Garmisch-Partenkirchen, May 28th 2009

Safety Notice UP Ascent 2 and Kantega XC

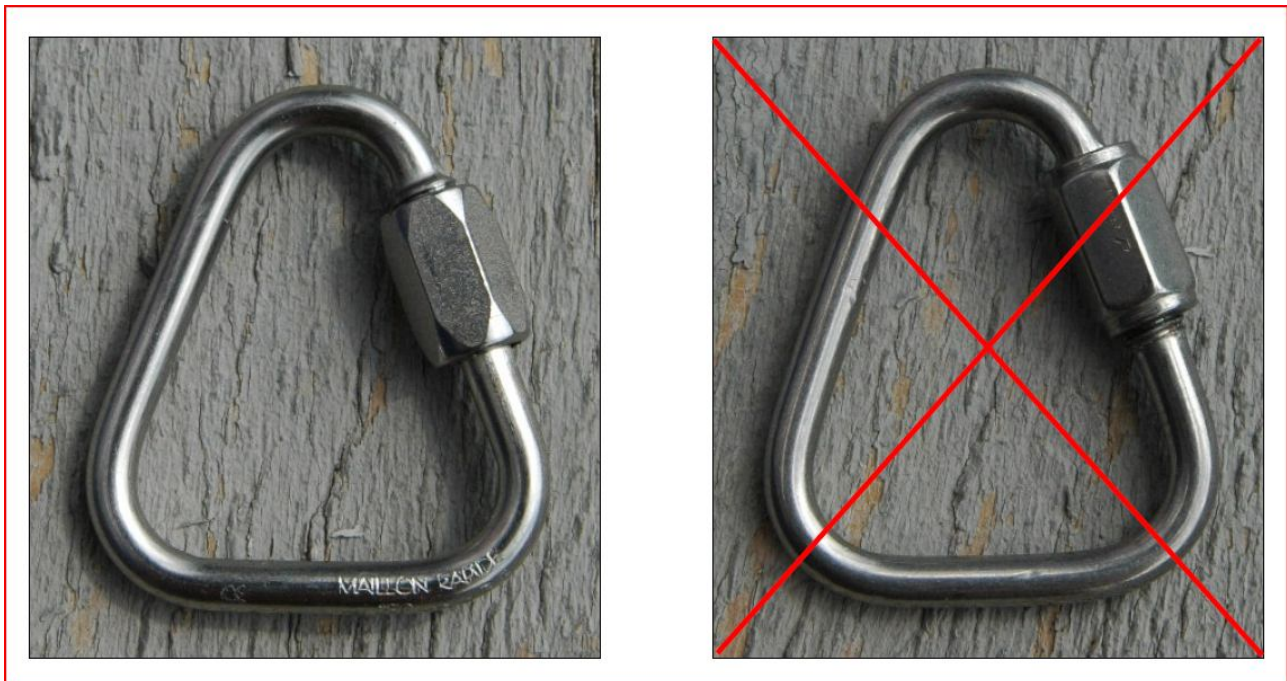
The problem with the King Snap maillons is, should excessive force be applied to the closure nut it is possible to turn it past the "closed" position and even to open it from the wrong end – if flown in this configuration the maillon is not strong enough, and may open under tension.

Easy to recognise from the Maillon Rapide stamp

No stamp, and notice the thread coming out of the bottom of the closure nut

Some of the abovementioned wings have been equipped with line maillons from the manufacturer King Snap. This can lead to a safety problem (described below) and UP International has decided to issue a safety notice in this regard, and to exchange all King Snap maillons with ones manufactured by our usual provider, Maillon Rapide of France.

We ask all owners of Ascent 2's and Kantega XC's to check their line connections and, should King Snap maillons be fitted, to send the Serial Number of the wing to the distributor for a free exchange. The distributor will also be able to help with detailed instructions on how to do the actual exchange.
